**TOWN OF NEWBURGH
PLANNING BOARD
TECHNICAL REVIEW COMMENTS**

PROJECT NAME: GOLDEN VISTA AMENDED SITE PLAN
PROJECT NO.: 99-33
PROJECT LOCATION: SECTION 60, BLOCK 1, LOT 9.1
REVIEW DATE: 26 MARCH 2015
MEETING DATE: 2 APRIL 2015
REPRESENTATIVE: JOHN MEYER CONSULTING

AMENDED SITE PLANS GOLDEN VISTA TAX MAP SECTION 60 | BLOCK 1 | LOT 9.1 MEADOW HILL ROAD TOWN OF NEWBURGH, NEW YORK

DATE: 05/07/2015
SCALE: AS SHOWN
SHEET: 30 OF 45
SP-7

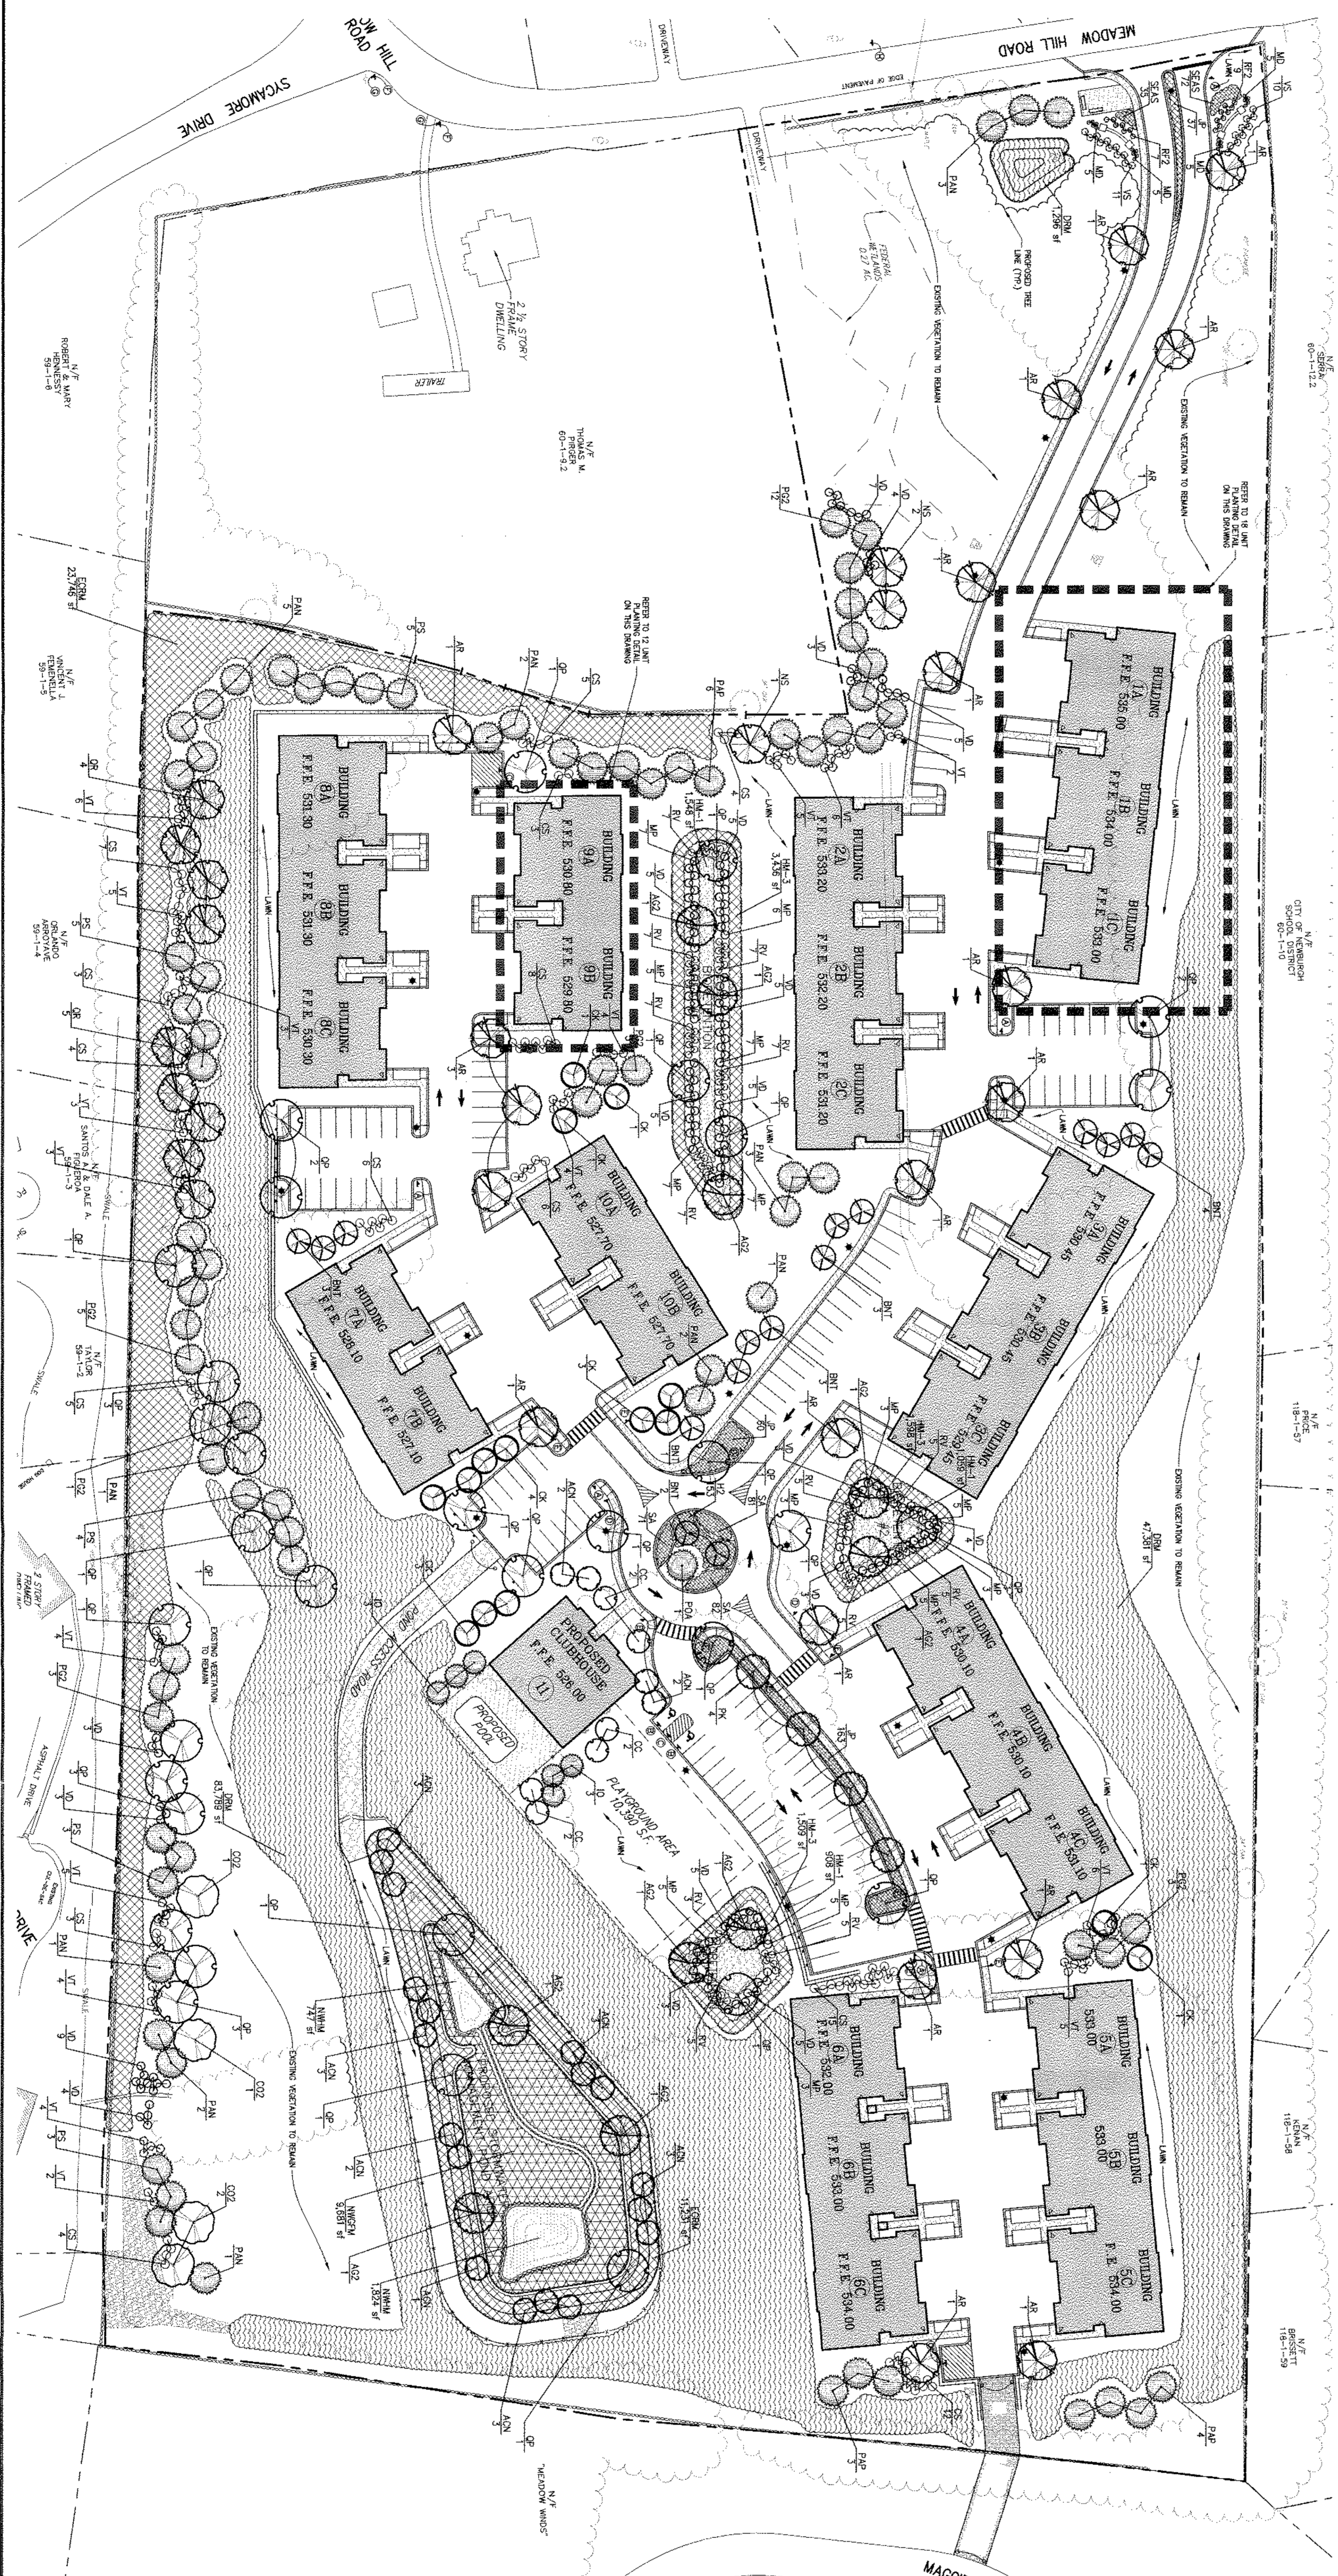
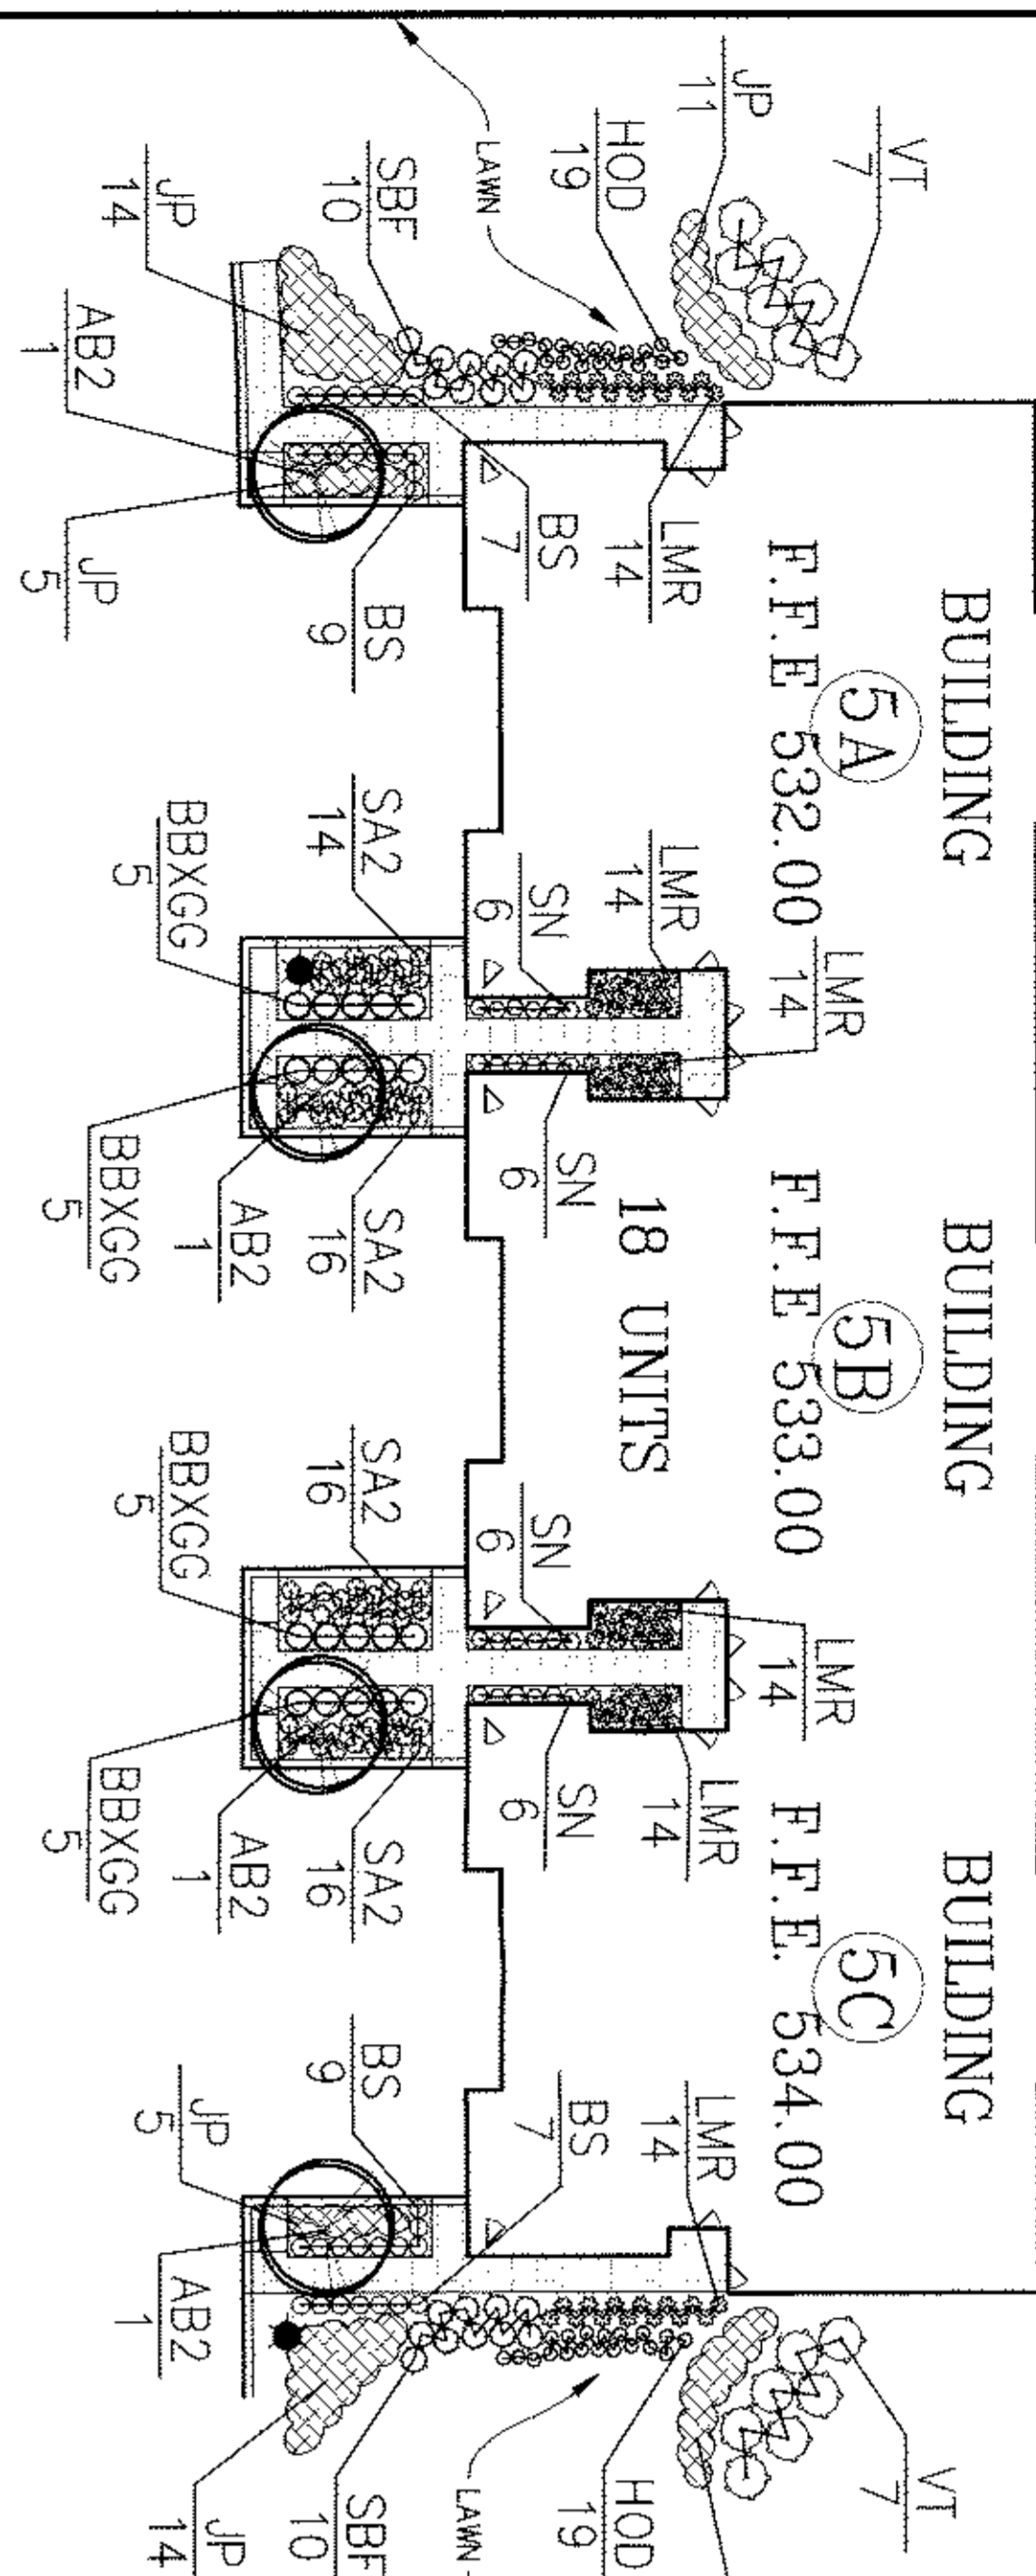
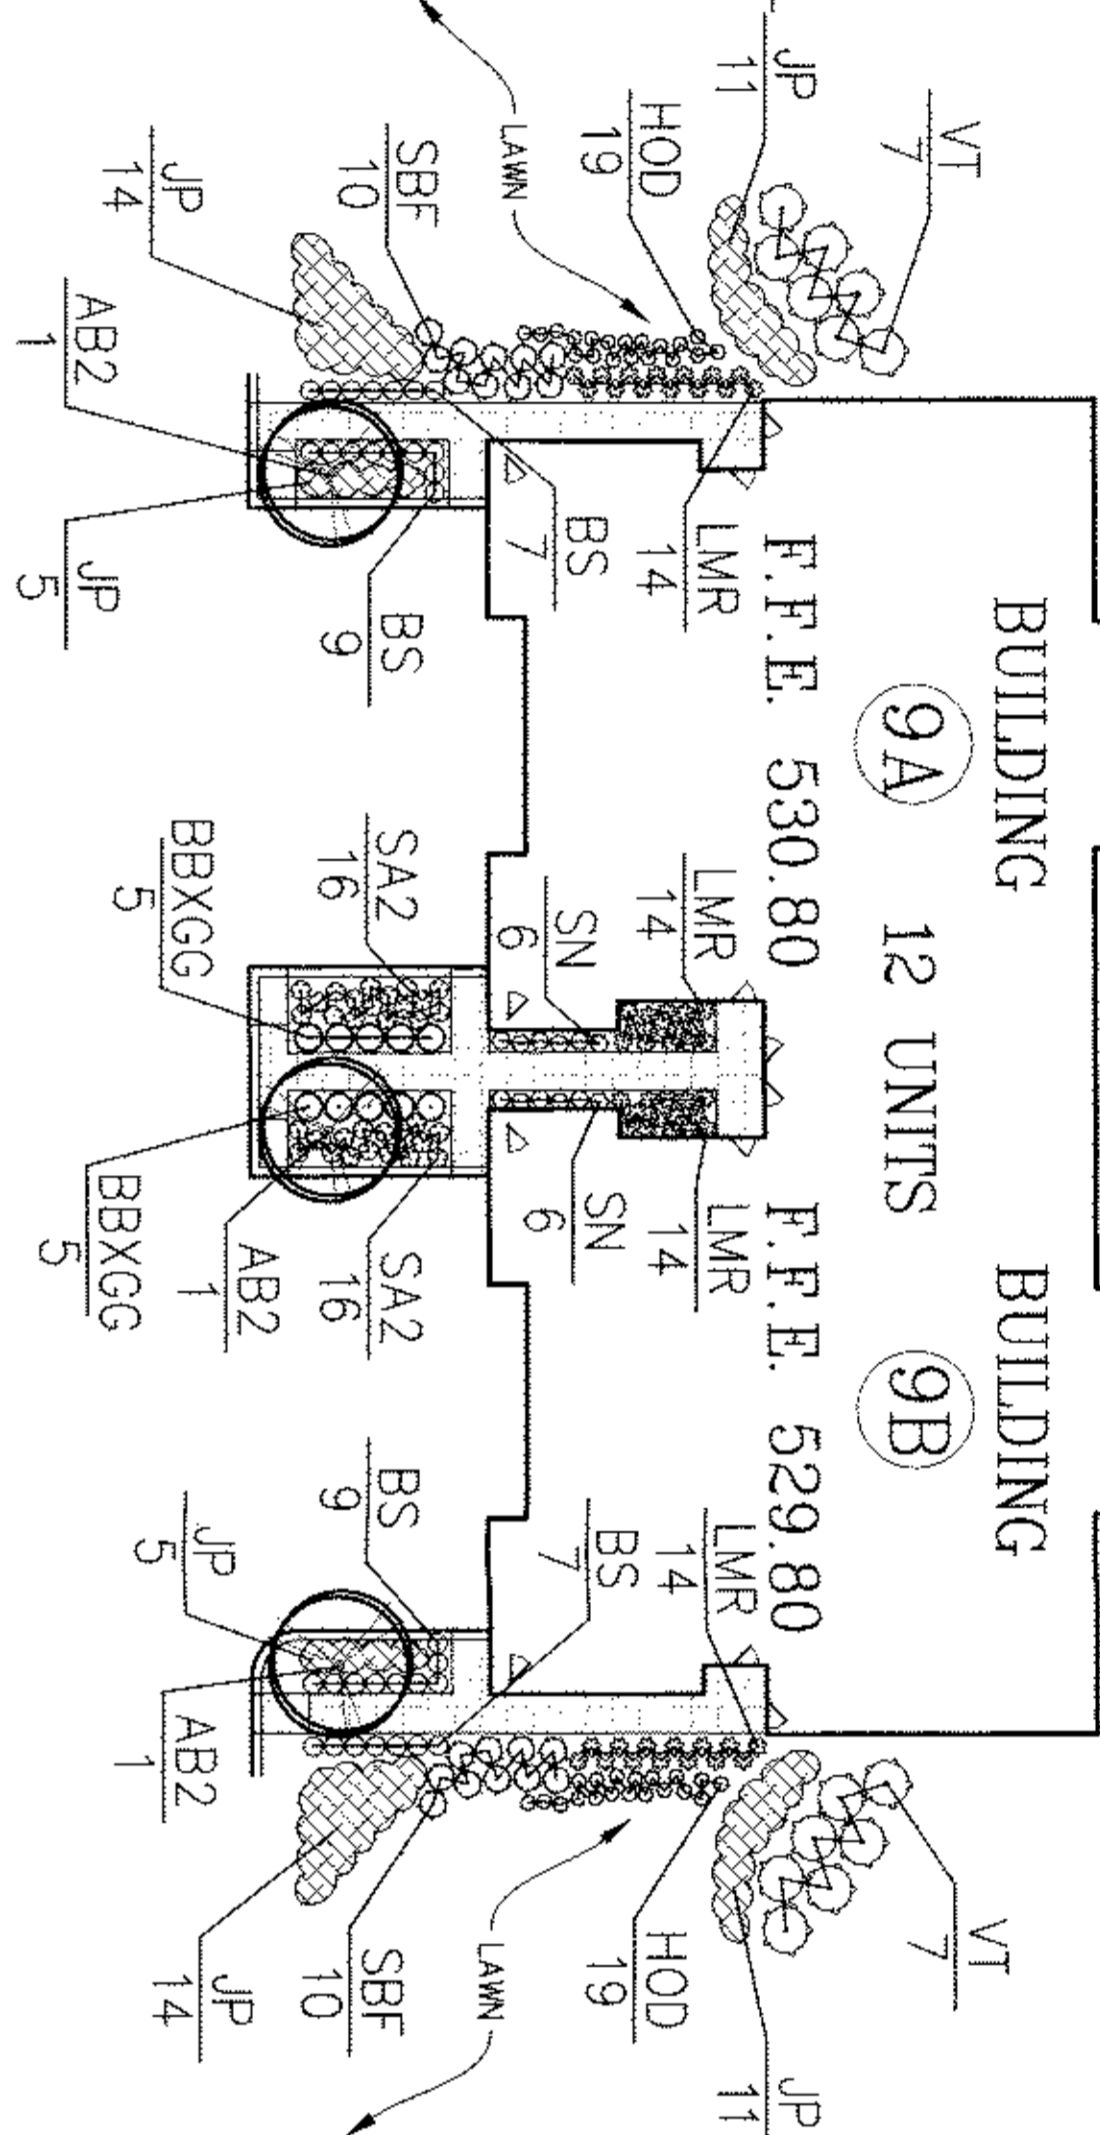
9. A revised landscape plan has been submitted for the Planning Board's review.
10. Notes referencing the Town Code regarding senior housing size requirements must be added to the plans. This can be added in addition to labeling the habitable floor area in the bulk table as senior units.
